**CITY PLANNING COMMISSION**

- APPLICATION:
1. Environmental Determination
  2. Rezone .3± vac. ac. from Duplex-Review (R-2-R) to townhouse (R-1A) zone.
  3. Tentative Map to divide .3± vac.ac. into 2 halfplex (R-1A) lots
  4. Special Permit to develop two halfplex units
  5. *SUBDIVISION MODIFICATION TO WAIVE SEWER AND WATER SERVICES.*
- LOCATION: South side of Pocket Road approximately 100± ft. west of Greenhaven Drive

PROPOSAL: The applicant is requesting the necessary entitlements to develop two halfplex units.

# TENTATIVE PARCEL MAP FOR: LOT 1-PARKWAY OAKS UNIT #1

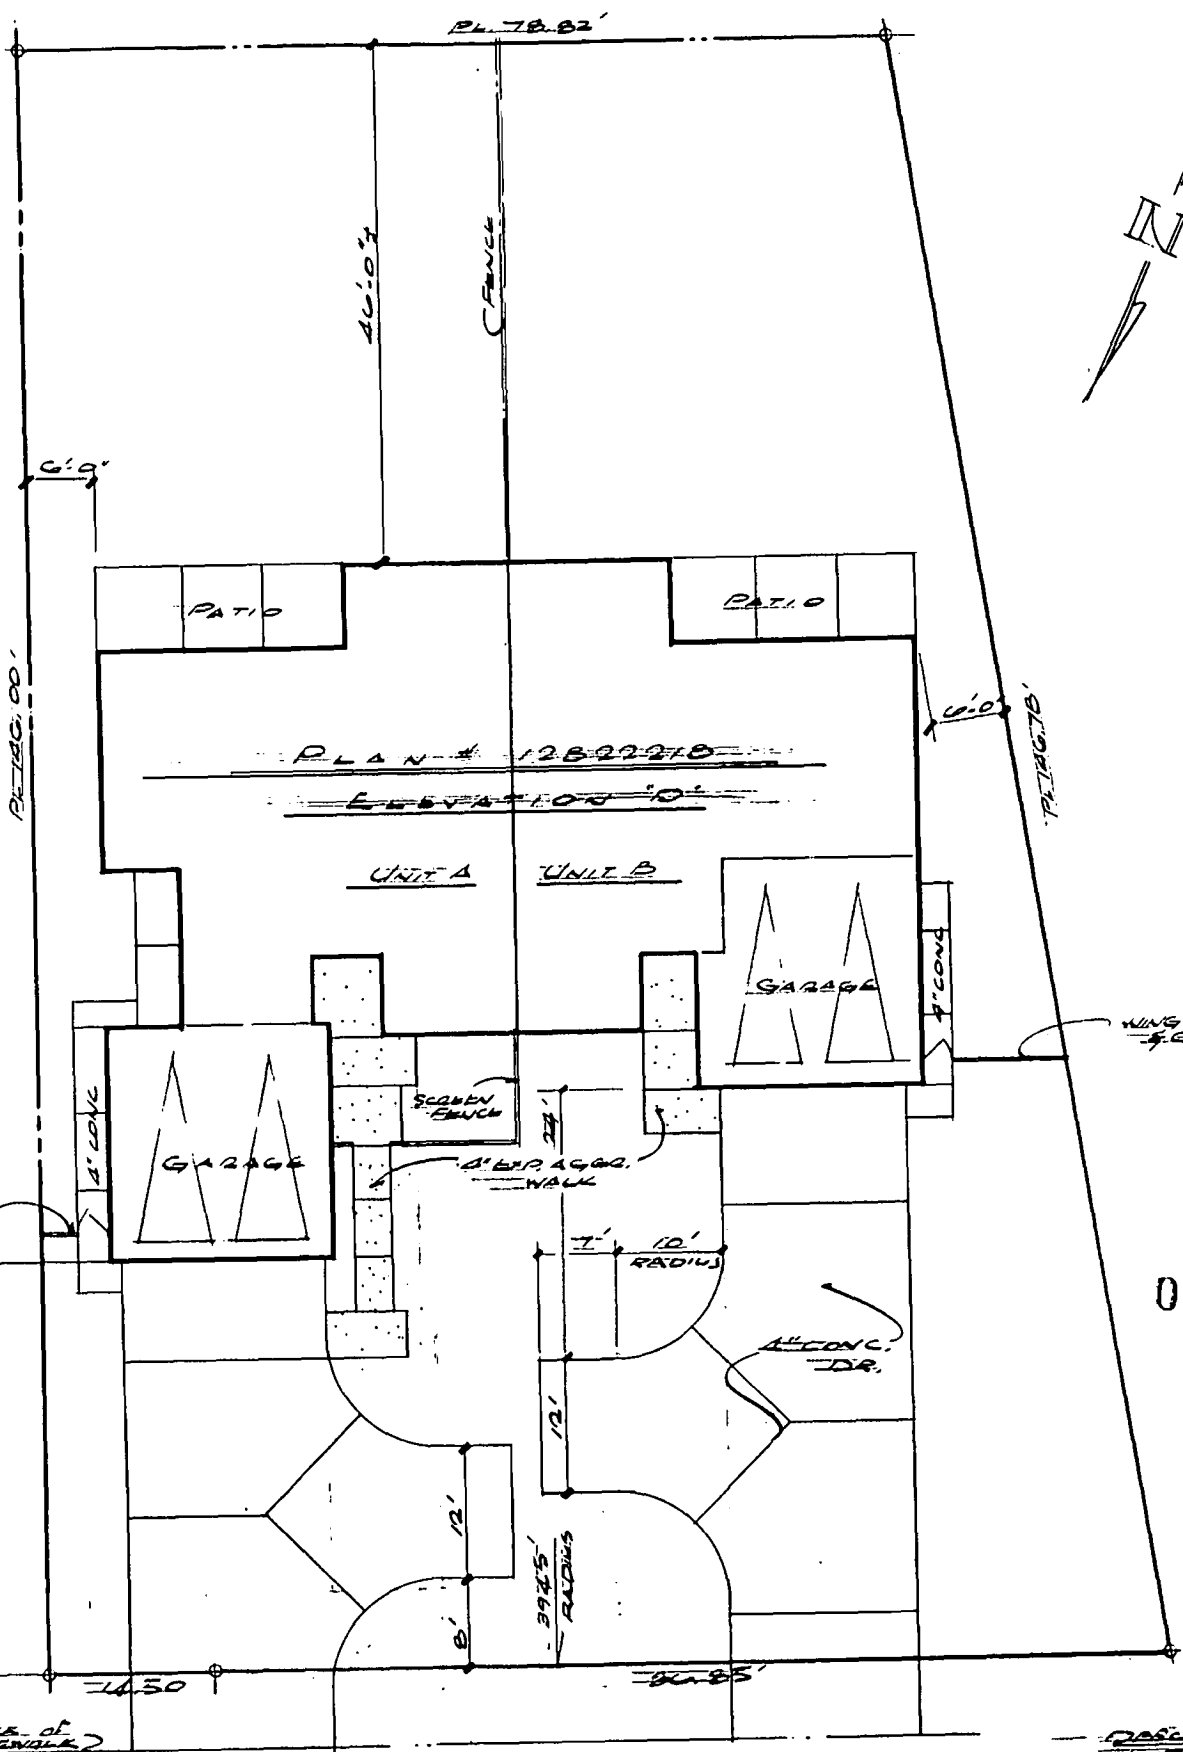
3. The site plan indicates a vehicular turnaround on Lot 2 that is eight-feet from the front property line. Staff would suggest that heavy landscaping be located between the turnaround and the public right-of-way. This is necessary to help buffer any cars that may be parked in this location.

- a. Shake roofing and varied exterior materials shall be used as shown on the submitted elevations.
- b. Heavy landscaping shall be installed between the vehicular turnaround on Lot 2 and the public right-of-way.
